Deadline 10 – Summary of Position

File Ref: PZ/CS/P21-2329/03TN

Subject: **Fordley Hall – Deadline 10 Submission**

Statement of Common Ground – Create Consulting on behalf of Mr and Mrs Grant

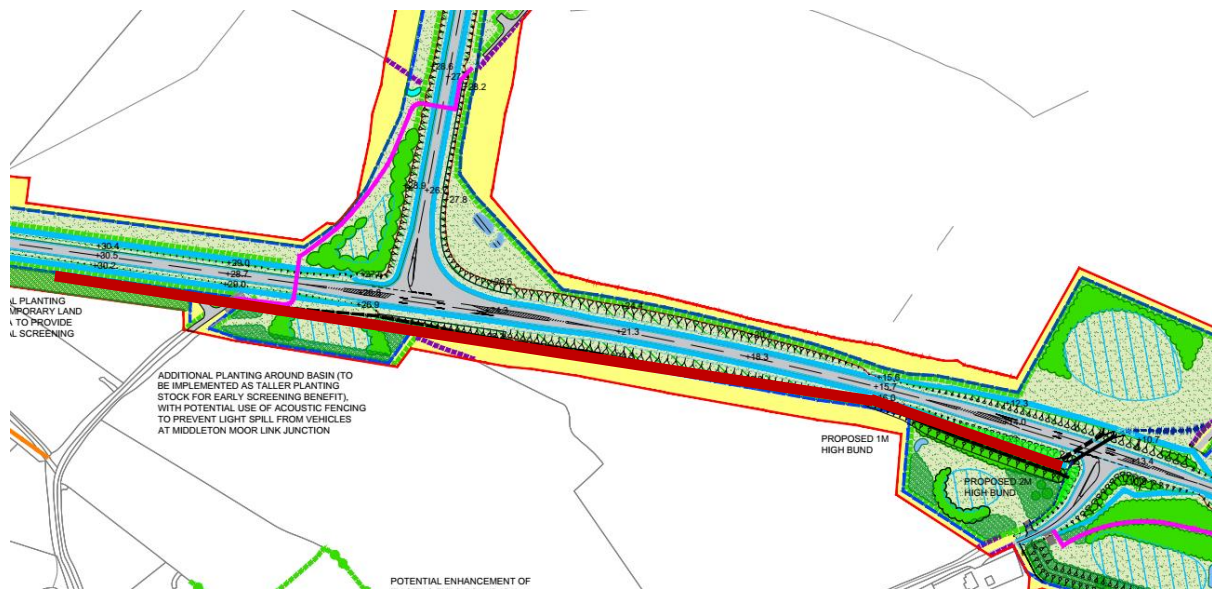
- 2.7 The 3m acoustic fence is proposed from the Littlemoor Road closure stopping approximately 60m east of the SLR / B1122 junction. A 1m to 2m bund is then proposed from the cutting / embankment interface to Fordley Road, as shown in the black dashed line.

- 2.8 Through discussions with the Applicant, Create have highlighted that the planned noise mitigation measures are not sufficient, both in terms of design or length, to provide a reasonable level of mitigation at Fordley Hall.
- 2.9 Create have highlighted to the Applicant that the current proposals fail to take into consideration the SLR alignment and current topography of the surrounding area and an alternative proposal has been suggested to the Applicant. This is indicated in the extract below as a solid red line and should be a 3m barrier.

- 2.10 The option suggested offers a level of noise attenuation which is considered reasonable against the ambient background noise levels.
- 2.11 Create suggest there is sufficient space within the DCO boundary for a bund to be provided rather than an acoustic fence, which can be landscaped to provide further protection from the potential light spill from the SLR.
- 2.12 This is not contained within the Statement of Common Ground and at this time Create await agreement from the Applicant to this change.

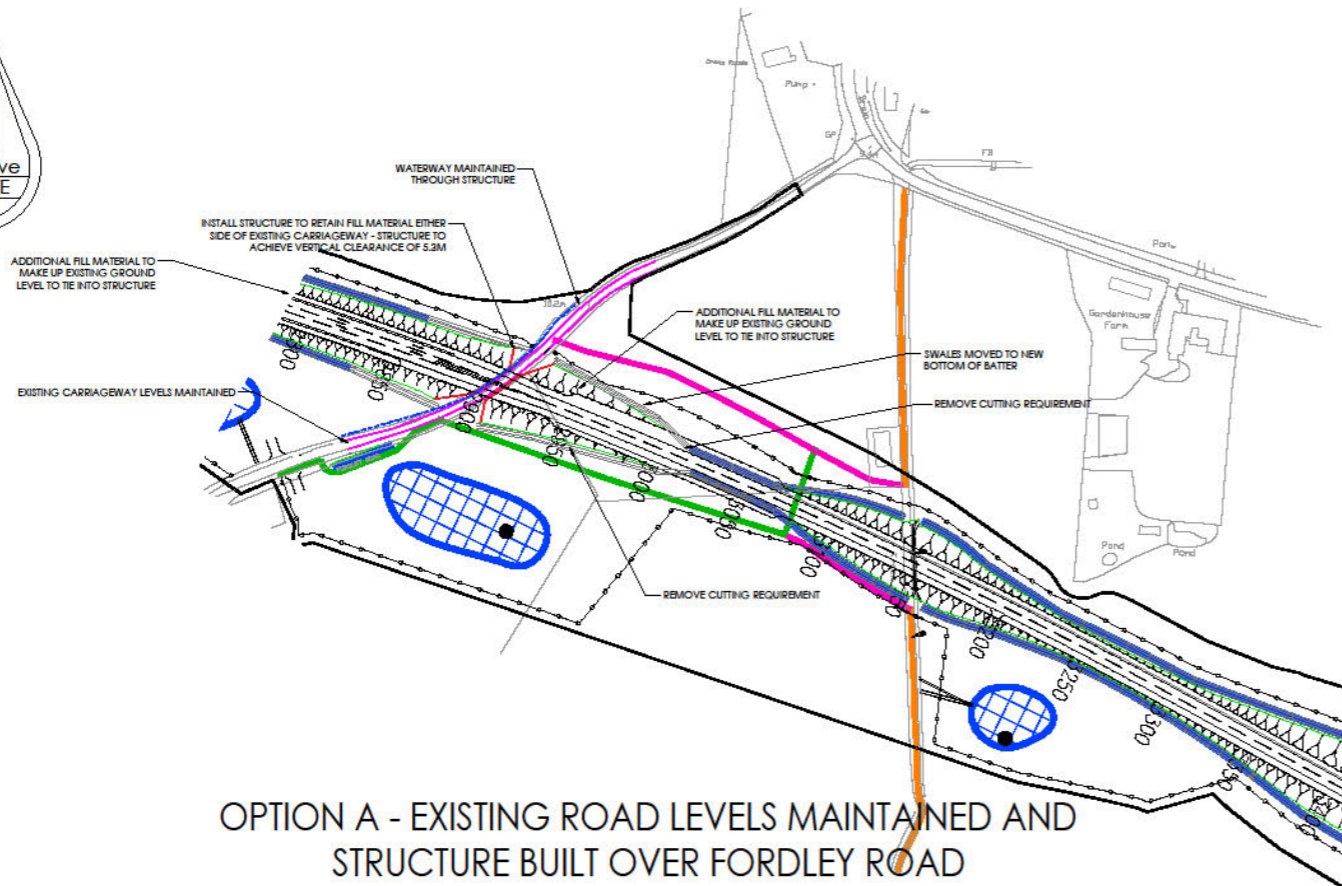
Option B indicates flood water would need to be pumped back out of the underpass. However, the sketch shows this being taken to the upstream side of the SLR and discharges upstream to flow through the culverted section of the diverted channel downstream. In addition, it is expected that Suffolk County Council Lead Local Flood Authority may ask that this is restricted and discharged at a greenfield rate, leading to the need to attenuate and store the water temporarily. Therefore, to create a depression and pump the fluvial flows suggested by the Create Consulting Engineers in Option B is considered to be unacceptable and would likely be strongly opposed by the Environment Agency. In addition, as the

pumping drainage approach is less sustainable it would be unlikely to receive support from Suffolk County Council as Lead Local Flood Authority.

- 1.24 The drainage proposal demonstrates an option to remove surface runoff from within the structure and road lowering, it would likely need to be pumped but is not insurmountable.

PROJECT SIZEWELL C LINK ROAD	DATE 19.05.21	DRAWING STATUS INFORMATION		
DRAWING TITLE FORDLEY ROAD OPTIONS	SCALE(S) 1:2000 @ A1	DESIGNED SC	DRAWN SC	
CLIENT DAVID GRANT (MIDDLETON)	JOB NO. P20-2187	CHECKED PZ	APPROVED PZ	
DRAWING No. 03_001		REVISION A

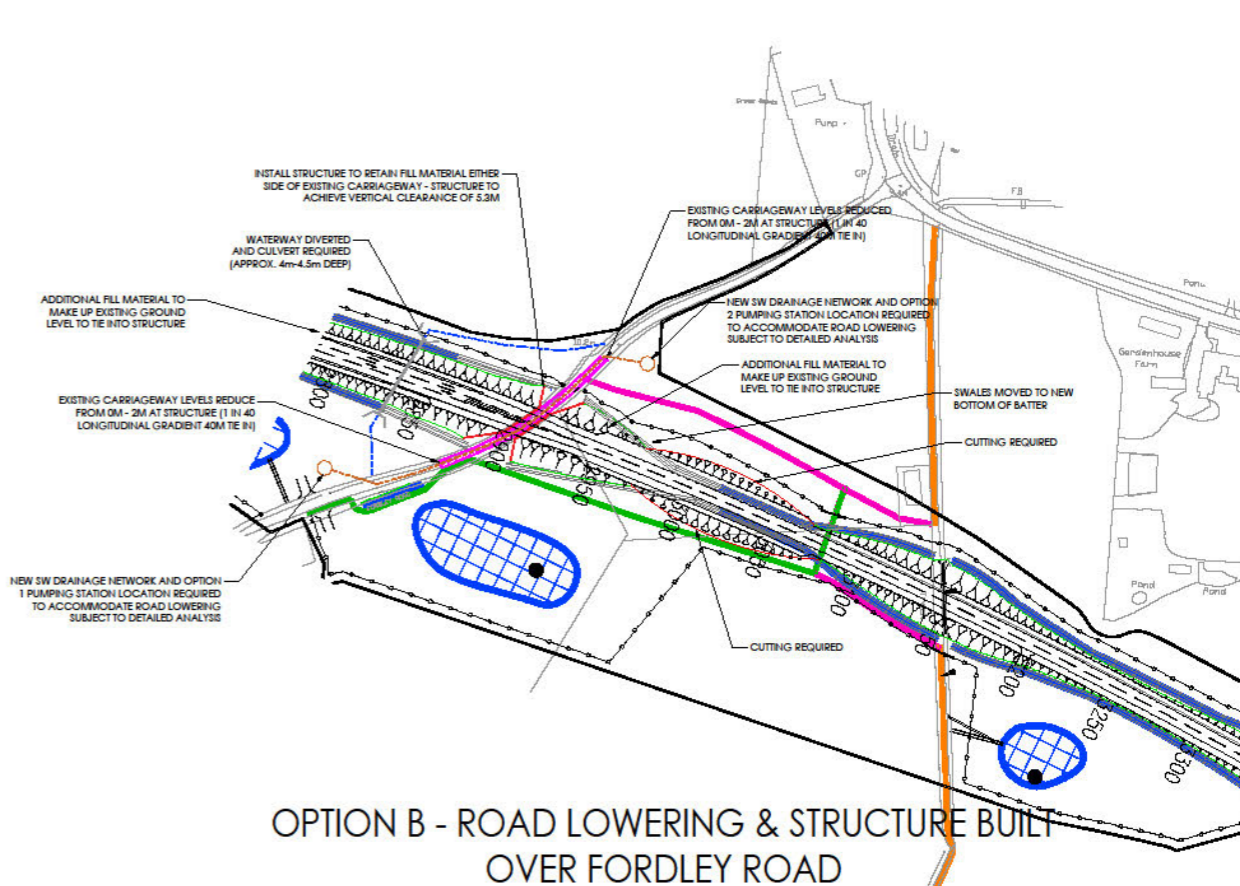
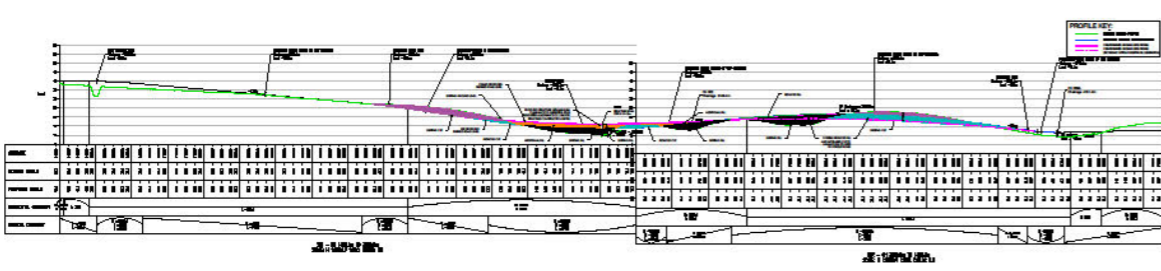
Create Consulting Engineers' Option A suggestion to provide the SLR crossing over Fordley Road (retained at its current level) with a minimum clearance of 5.3m to the underside of the SLR shows the Project longsection alignment lifted some 3.5m. The SLR is already on a 3.5m high embankment thereby the alignment suggested is over 7m in height at Fordley Road. An increase in embankment height of this magnitude at this location is considered a severe impact on the landscape and an unacceptable detrimental impact on the adjacent Vale Cottage properties.

The Create Consulting Engineers' Option A plan layout shows an underpass at SLR chainage 2900 and the long section shows it at chainage 2850. This is assumed to be an error and the underpass on the long section should also be at chainage 2900 which would change the vertical alignment suggested as a result. The long section underpass position would therefore need to move eastwards to match the plan position.

The Create Consulting Engineers' suggested vertical road profile is shown to dip either side of the underpass location which would reduce driver visibility and introduce a safety concern with vehicles being partly hidden in the dip. The Suffolk County Council highway design standards vertical curvature and site stopping distances for the dipped sections is below the requirements of a 60 mph speed limit and would therefore not likely be an acceptable safe design to the highway authority. The Create Consulting Engineers' Option A is therefore also rejected on highway design safety considerations.

The Create Consulting Engineers' Option B suggestion of lowering Fordley Road beneath the SLR with a proposed pumping station was considered but would create a significant localised depression in the landscape which would result in an increased risk of flooding of the road, noting that the Middleton Drain watercourse running alongside Fordley Road is the responsibility of the Environment Agency.

The clearance from Fordley Road to the underside of the SLR bridge is shown at Option B at a minimum of 5.3m which would cause a significant depression. Fordley Road would also need to be lowered some 3m over a reasonable distance to meet road design standards. To create the required depression for Option B, the lowered Fordley Road would require a cutting embankment in excess of 200m in length and some 7.5m high to the east at a width of up to 22m, and a cutting embankment 3.5m deep to the west at a width of up to 11m.

- 1.1 Create have reviewed and revised Option A, this is provided in Appendix C.
- 1.2 The height above Fordley Road is reduced to demonstrate a reduced impact on the adjacent property. The vertical height required is close to the elevated topography to the east, which could be graded into the existing landscape. Option A also omits the need to cut into the immediate existing increasing landscaping to the east. Vegetation could be erected to help screen the SLR from Oakview House (Vale Cottage) property and they will benefit from Fordley Road remaining open as would all residents of Fordley Road and Middleton Moor.

- 1.3 Create have revised Option A.
- 1.4 This reduces the previous amount of fill that may be required. Note that your location of CU001A appears to be overlaid over the existing watercourse on the long section which differs to the layout plan for the watercourse diversion.

- 1.5 In the updated Option A the vertical road profile mitigates any dipped sections to generate a vertical curvature that would be acceptable to Suffolk County Council and have an acceptable visibility, this is considered acceptable and viable.

- 1.19 Option B has been revised (similarly to Option A) with the structure repositioned on the long section and provided in Appendix B.

- 1.20 The revised Option B plans demonstrate that a combination of road lowering and increasing the height of the SLR could be achieved. Fordley Road could be reduced by 1m which would mean only a 1.6m height increase to the SLR. This in turn reduces materials required to build up adjacent SLR embankments east and west of Fordley Road.
